PLANNING AND ZONING COMMISSION PUBLIC HEARING MEETING
CITY HALL, 385 SOUTH GOLIAD STREET, ROCKWALL, TEXAS
FEBRUARY 10, 2026 IN THE CITY COUNCIL CHAMBERS AT 6:00 PM

(3) **P2025-045 (HENRY LEE)**

(4) **SP2025-048 (HENRY LEE)**

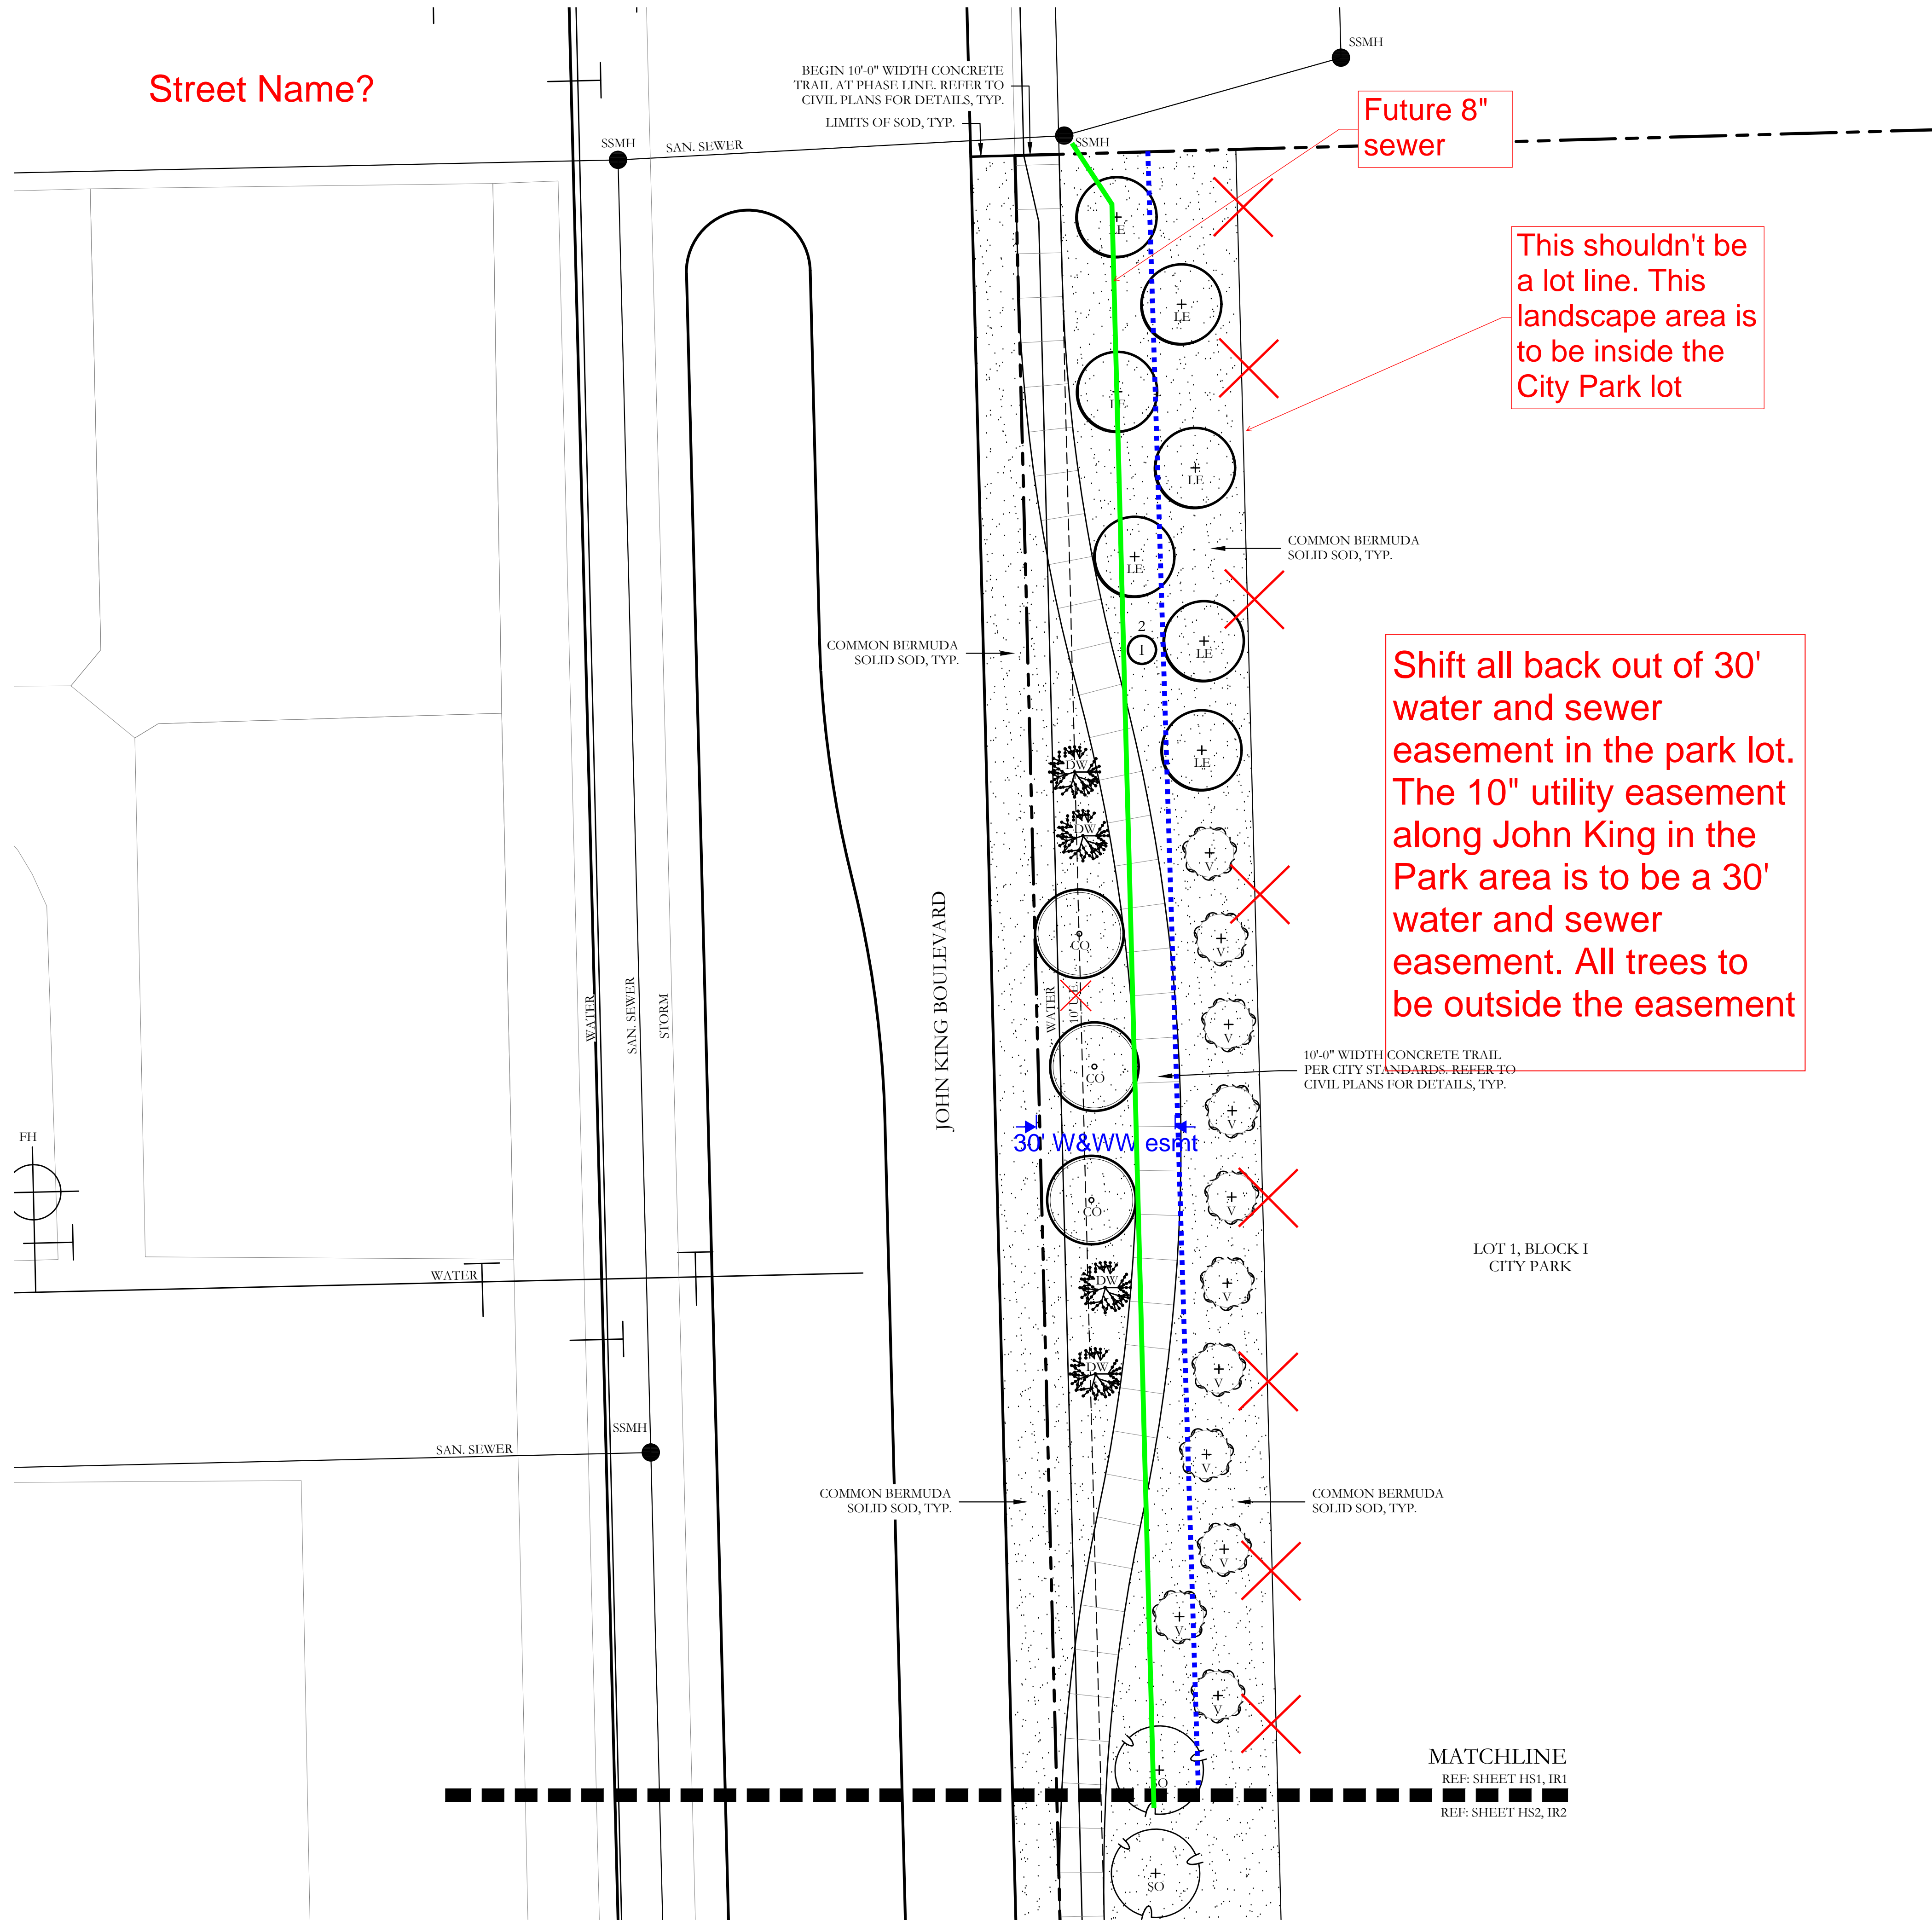
Street Name?

Future 8" sewer

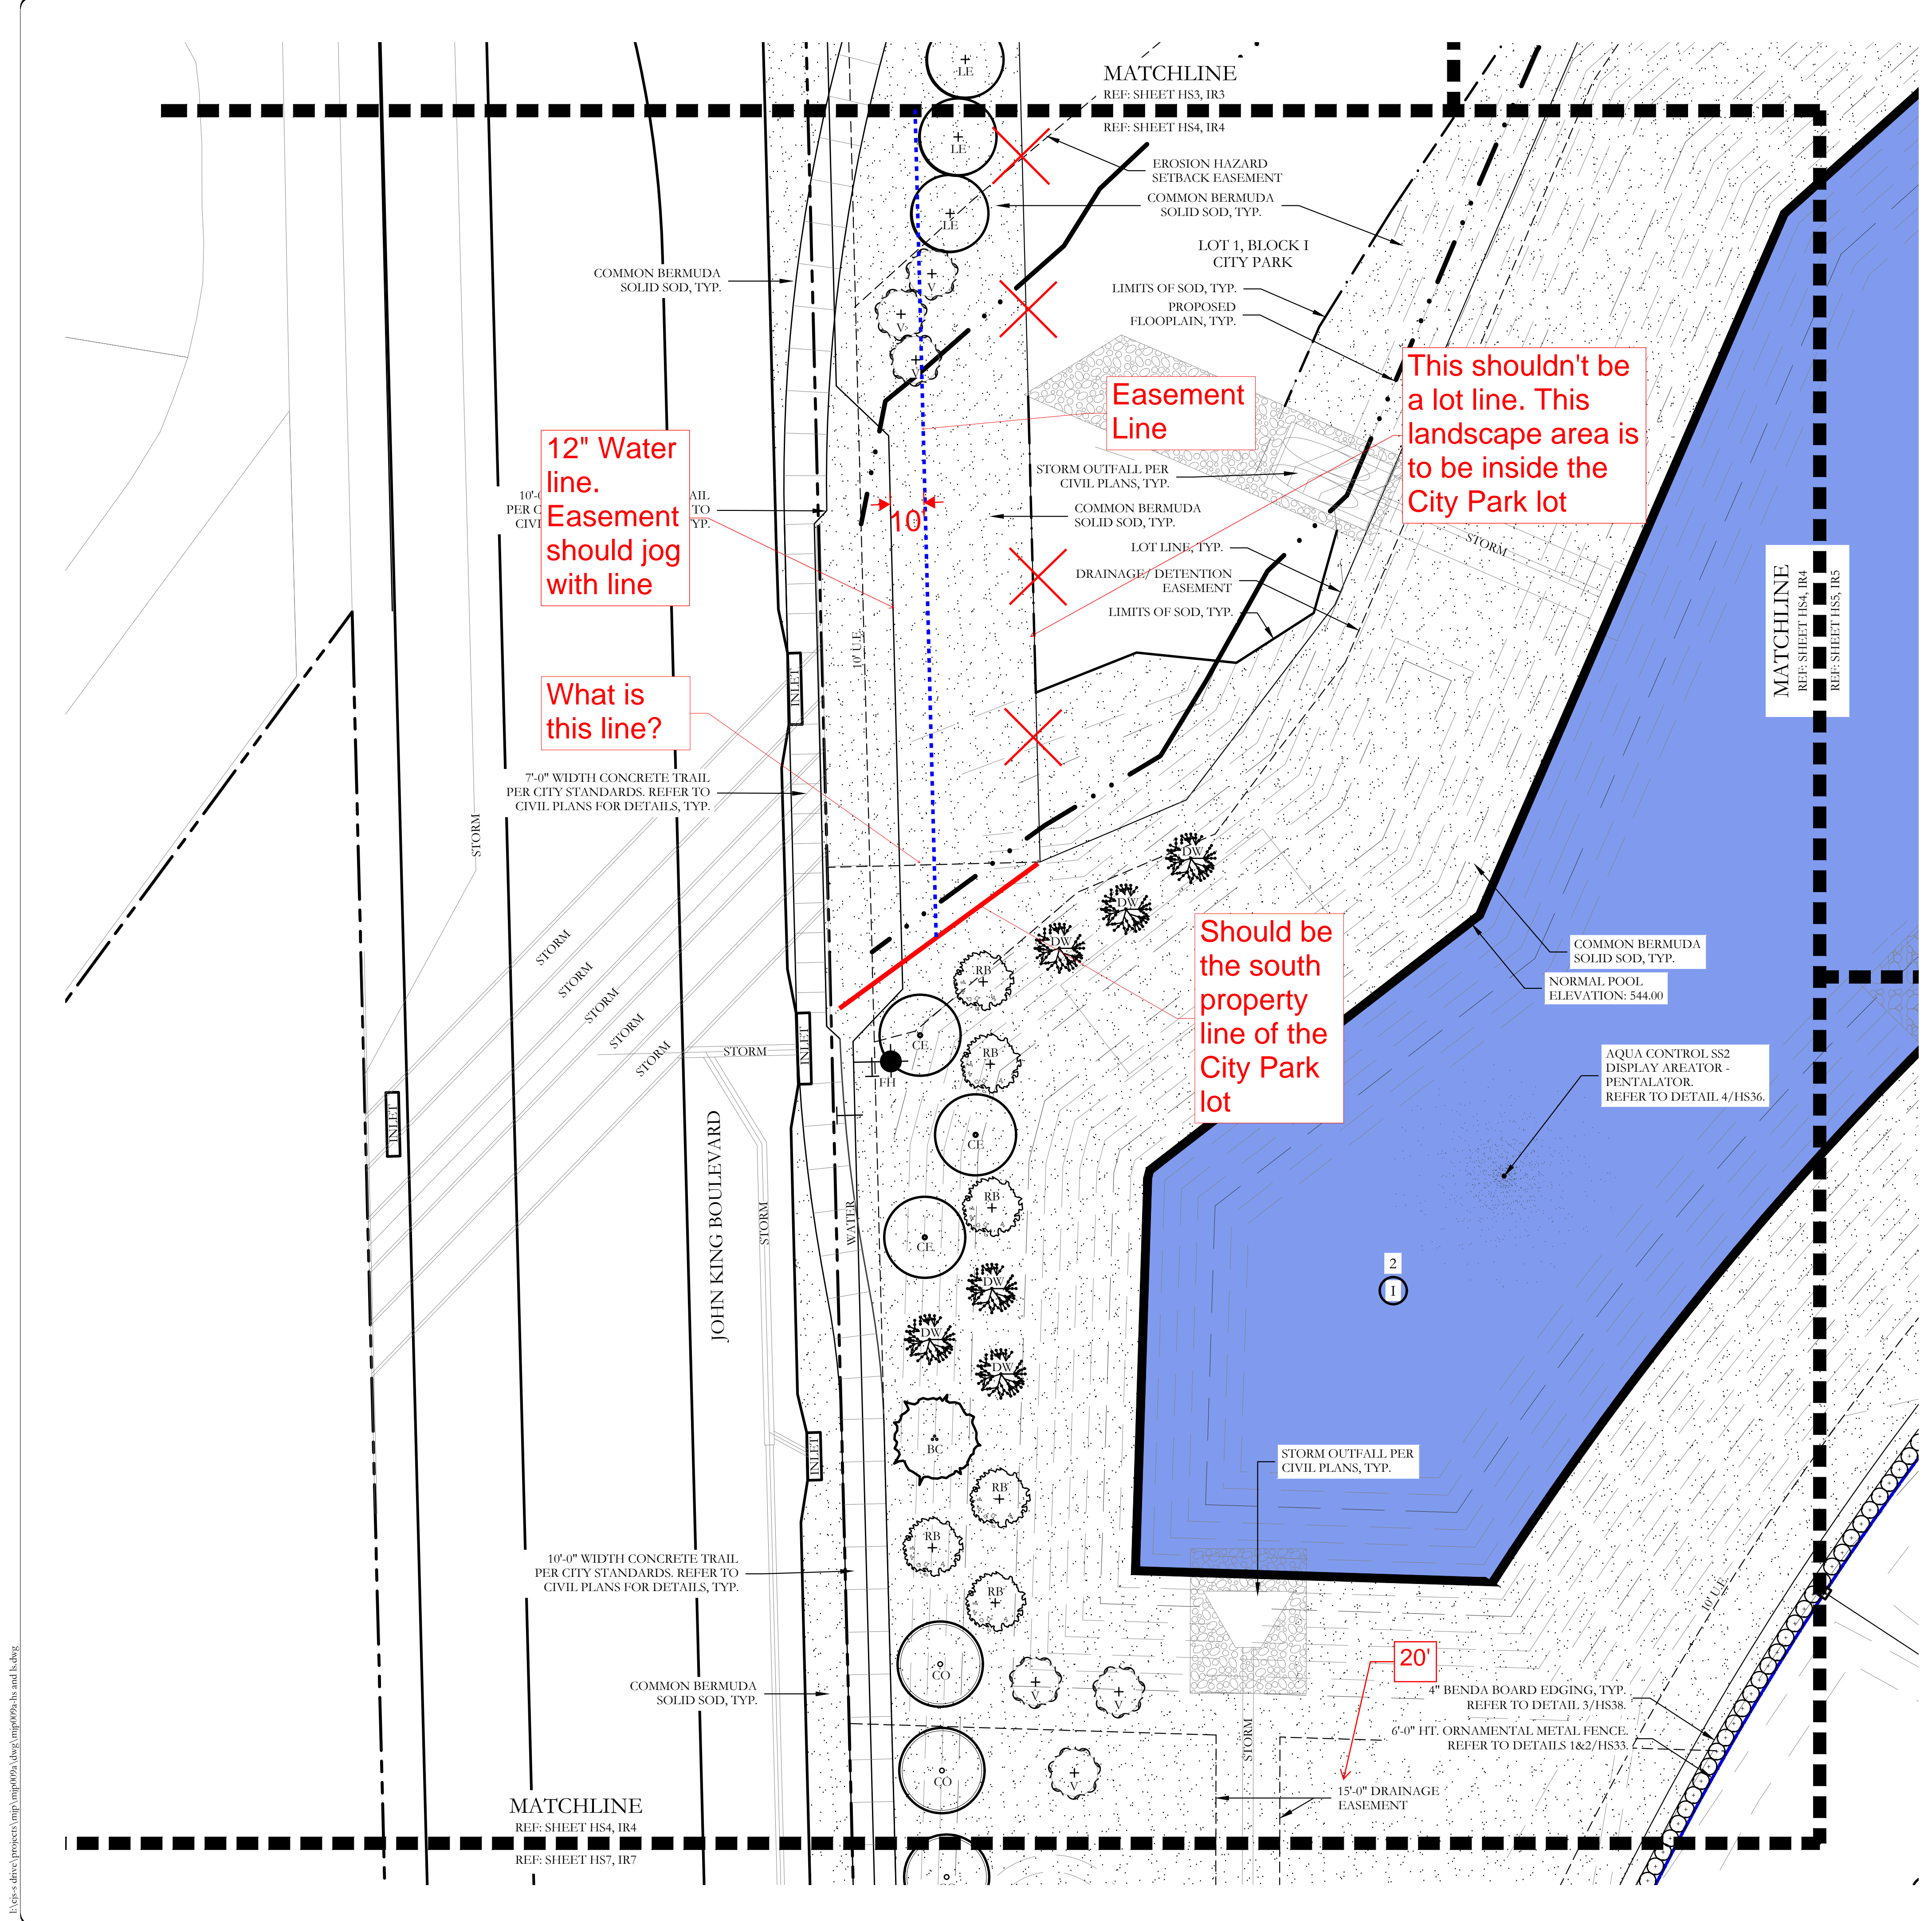
12" Water line. Easement should jog with line

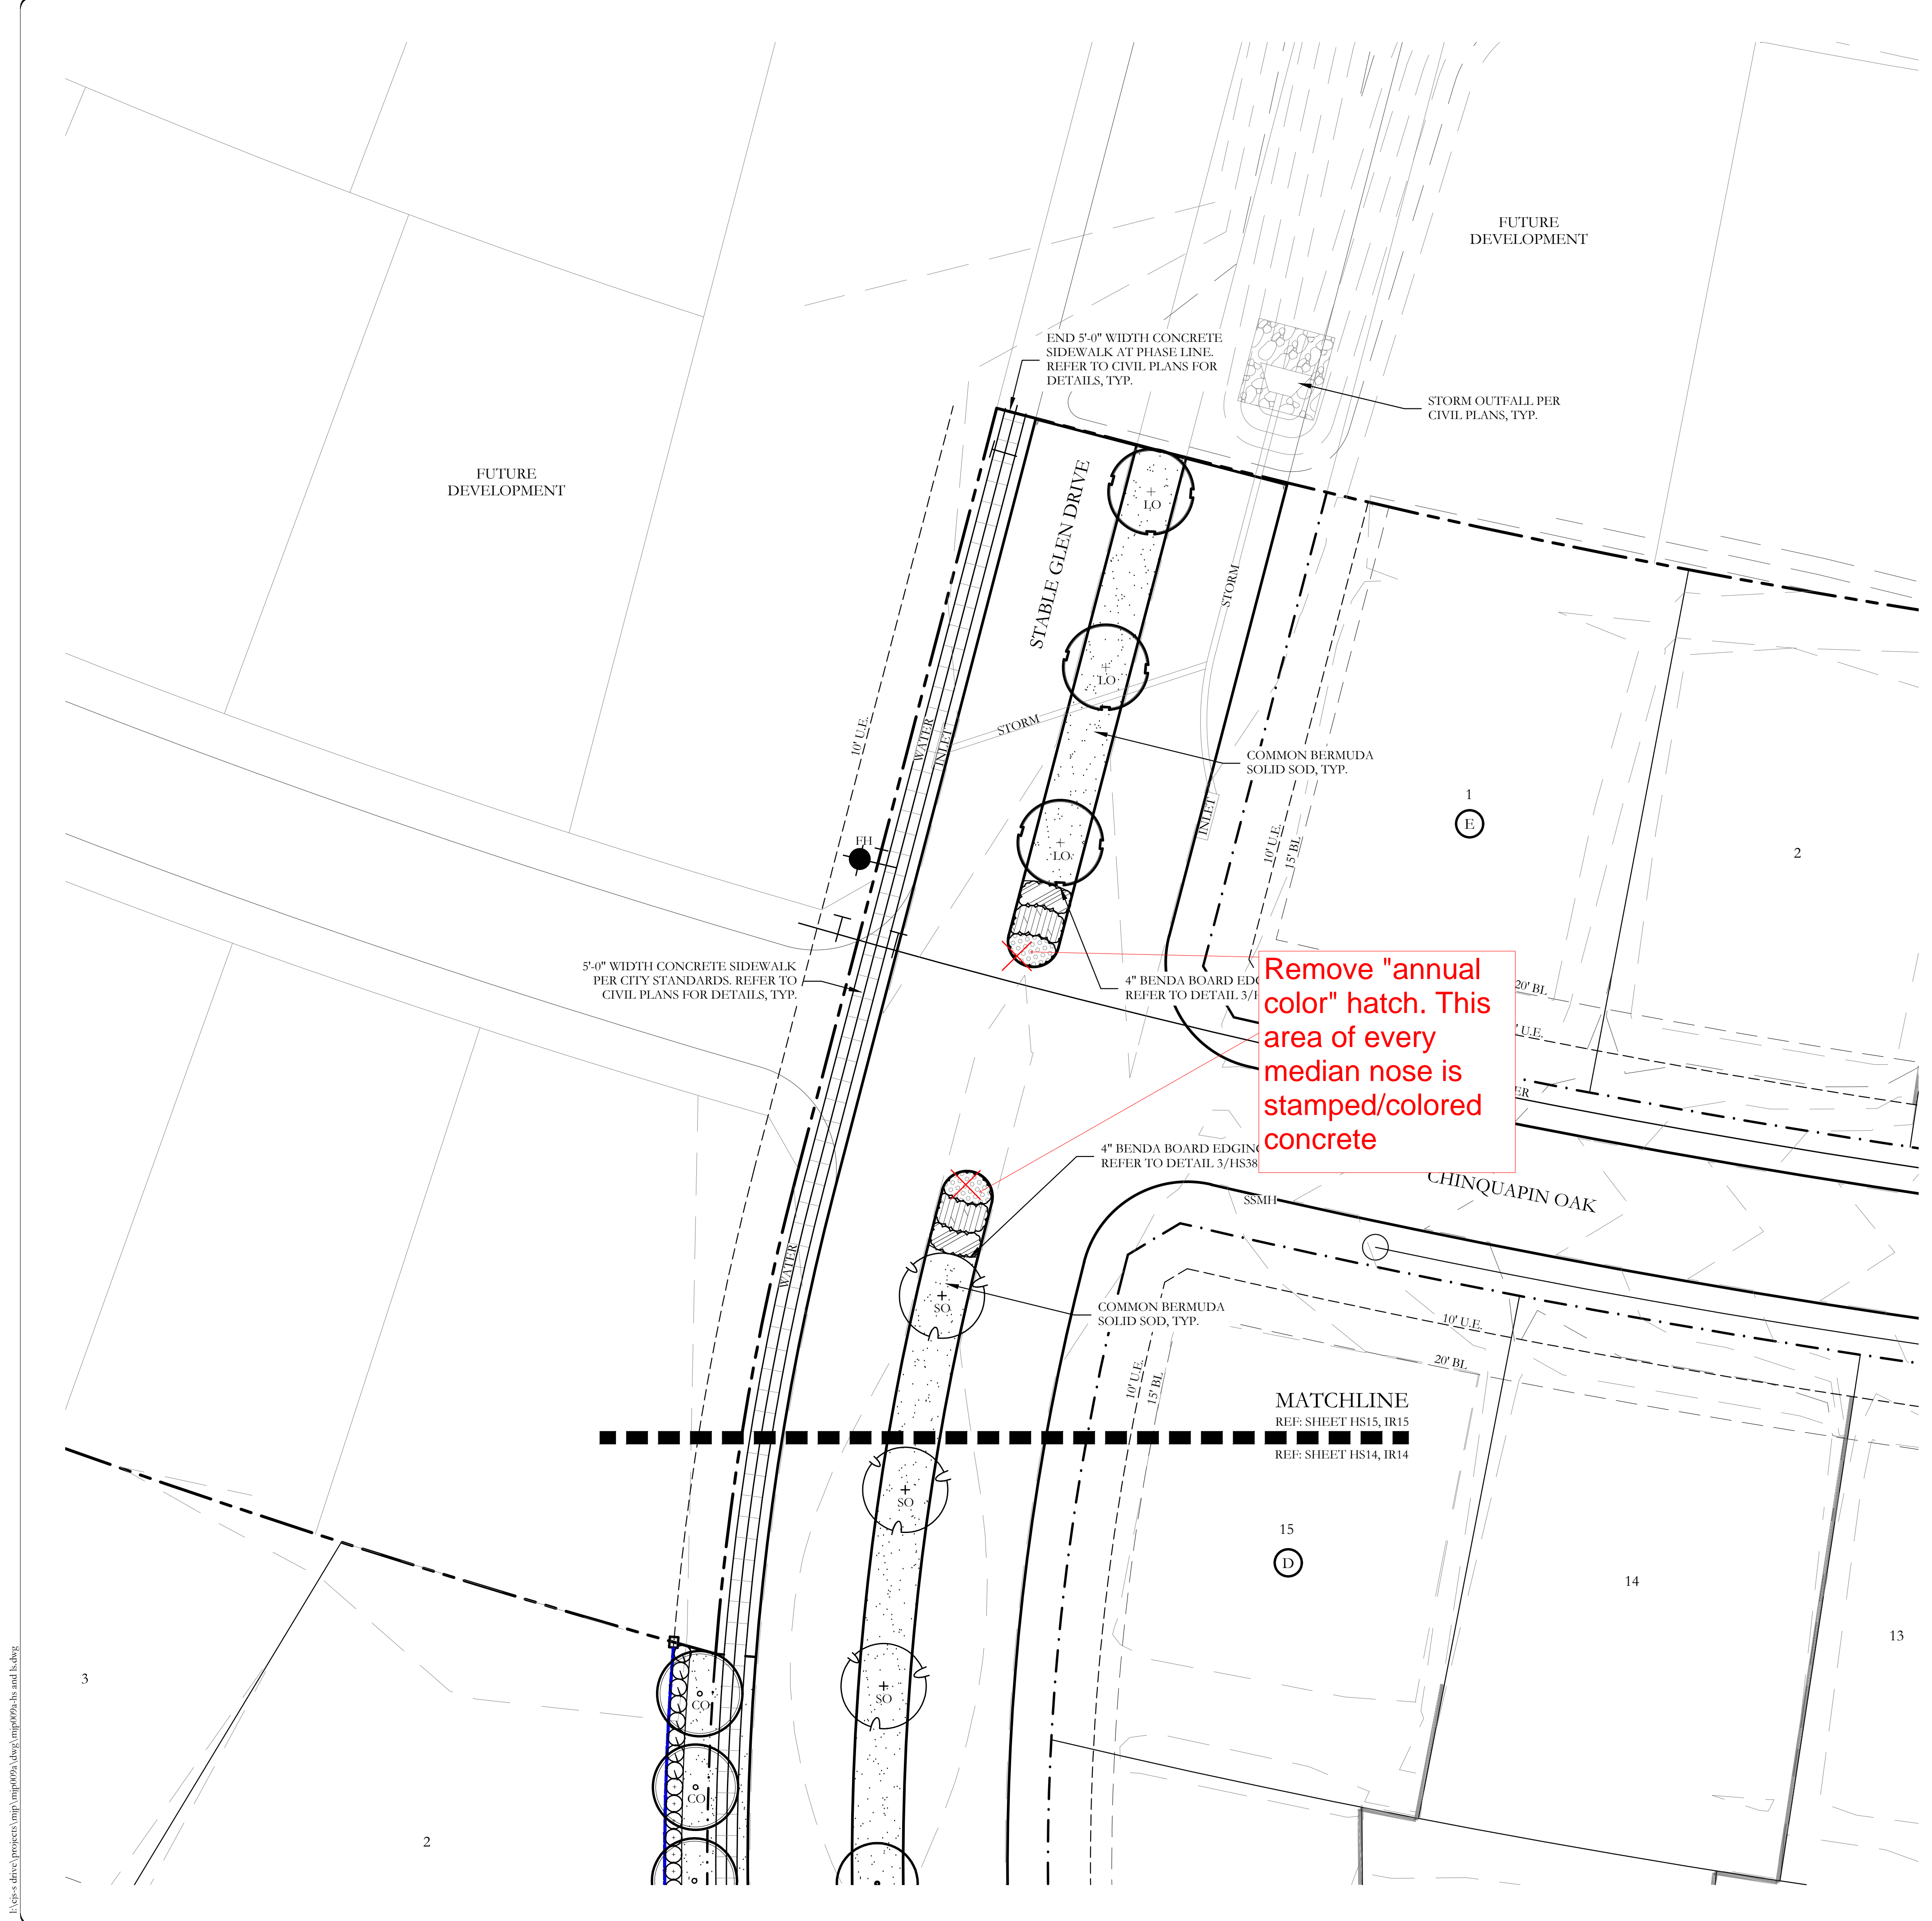
Remove "annual color" hatch. This area of every median nose is stamped/colored concrete
